dsPIC33EPXXX(GP/MC/MU)806/810/814 and PIC24EPXXX(GP/GU)810/814 Family Silicon Errata and Data Sheet Clarification

The dsPIC33EPXXX(GP/MC/MU)806/810/814 and PIC24EPXXX(GP/GU)810/814 family devices that you have received conform functionally to the current Device Data Sheet (DS70616G), except for the anomalies described in this document.

FIGURE 1: SIMPLIFIED BEHAVIOR

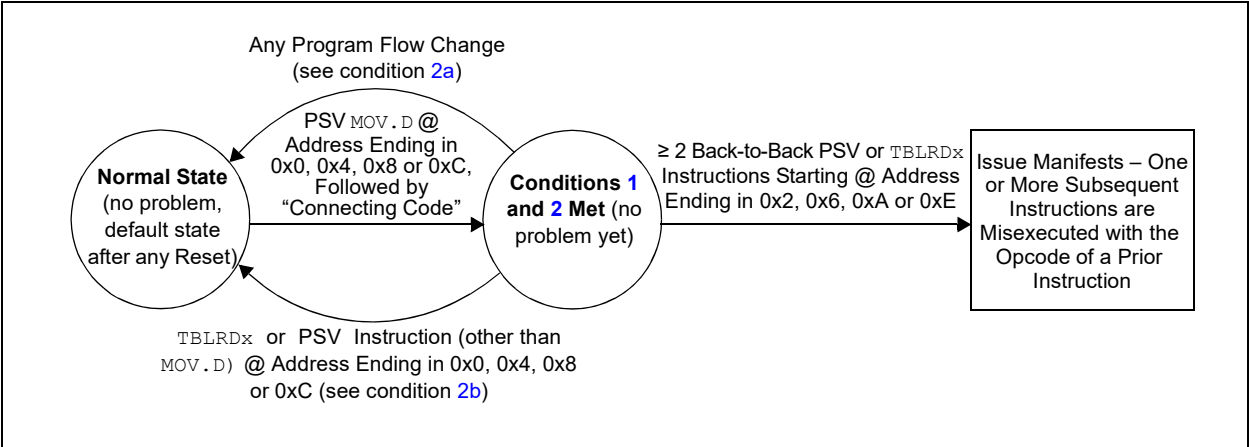
When two or more data Flash read instructions (via Program Space Visibility (PSV) read or table read) are executed back-to-back, one or more subsequent instructions can be misexecuted when all of the conditions in Table 3 occur.

1.	A PSV <code>MOV.D</code> instruction is executed, with opcode at address ending in 0x0, 0x4, 0x8 or 0xC; and
2.	Some “connecting code” is executed (following the <code>MOV.D</code> of condition 1), with the properties: a) The connecting code does not include any program flow changes, including: taken branch instructions (including all versions of <code>BRA</code>, <code>CPBEQ</code>, <code>CPBGT</code>, <code>CPBLT</code>, <code>CPBNE</code>), <code>CALL</code>, <code>CALL.L</code>, <code>GOTO</code>, <code>GOTO.L</code>, <code>RCALL</code>, <code>RETLW</code>, <code>RETURN</code>, vectoring to an ISR, returning from an interrupt (<code>RETFIE</code>) and certain debug operations, such as <code>break</code> and <code>one-step</code>; and b) The connecting code does not include a <code>TBLRDx</code> or non-<code>MOV.D</code> PSV instruction, located at a Flash memory address ending in 0x0, 0x4, 0x8 or 0xC; and c) The connecting code is at least two instruction words in length; and d) The connecting code does not end with a <code>REPEAT</code> instruction, with count > 0; and

3.	≥ 2 back-to-back PSV or <code>TBLRDx</code> instructions are executed (following the code of condition 2), where the first of the back-to-back instructions is located at an address ending in 0x2, 0x6, 0xA or 0xE.

Figure 1 provides an example of the effective behavior.

The issue can be avoided by ensuring any one or more of the requirements are not met. For example:

1. All instances of PSV `MOV.D` can be replaced with two PSV `MOV` instructions instead. Non-PSV `MOV.D` instructions acting on RAM/SFRs do not need to be modified; or
2. If not already present, a program flow change instruction (such as `BRA $+2`) can be inserted above back-to-back data Flash read sequences; or
3. Back-to-back data Flash read instruction sequences can be broken up by inserting a non-Flash read instruction (such as a `NOB`) in between the Flash read instructions; or
4. The alignment of the code can be shifted to avoid the required opcode location addresses.

C code built with MPLAB® XC16 Compiler, Version 1.32, or later, implements the work around by default. However, if the application uses Assembly language routines, these should be manually modified to implement the work around. Additionally, if precompiled libraries are used, these should be built with XC16 Version 1.32 or later. For additional information, please visit: www.microchip.com/erratum_psrds_psrds.

FIGURE 16-2: HIGH-SPEED PWM MODULE REGISTER INTERCONNECTION DIAGRAM

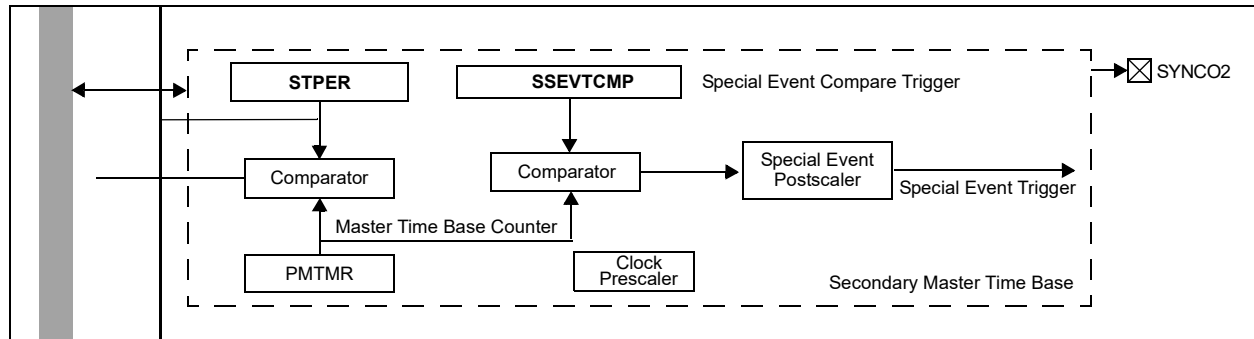
In **Figure 16-2: High-Speed PWM Module Register Interconnection Diagram**, the Secondary Master Time Base section has been updated. The updated text is shown in **bold** in [Figure 16-2](#) below.
